JOHN D. MAXWELL  
GEOLOGIST  
5322 WESTERN HILLS DRIVE  
AUSTIN TEXAS 78731

0 11 40  
February 16, 1981

Subject: Seismic Safety Margins Research Program Review,  
January 29-30, 1981

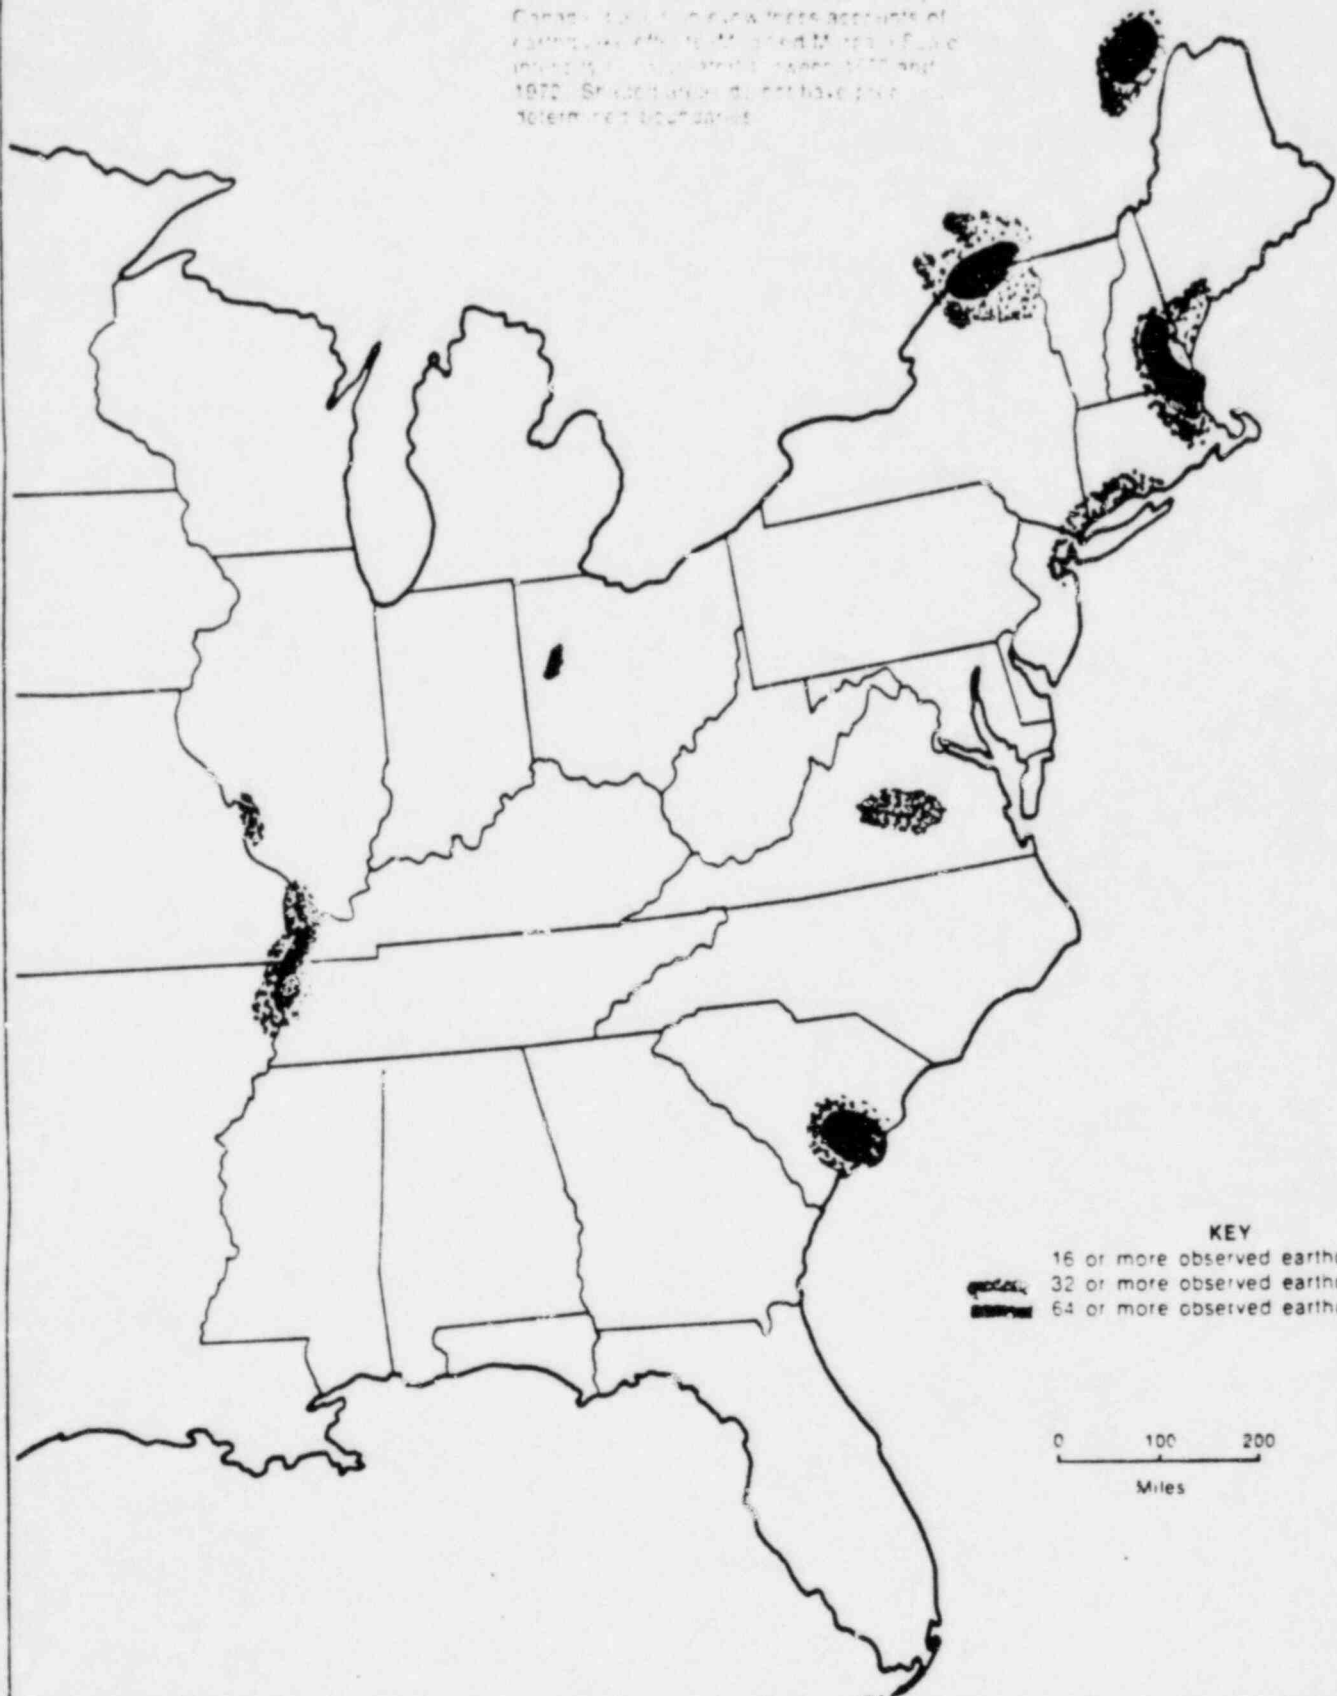
Determination of the state of stress in the crust, published by Zoback and Zoback (Journal of Geophysical Research, November 10, 1980, p. 6148) show graphically the vastly larger number of faults or active structural features from which stress may be determined or inferred in the Cordillera as compared to the eastern portion of the continent. The stress provinces so defined might logically be a basis for division of the continent for the phase II and III SSMRF studies.
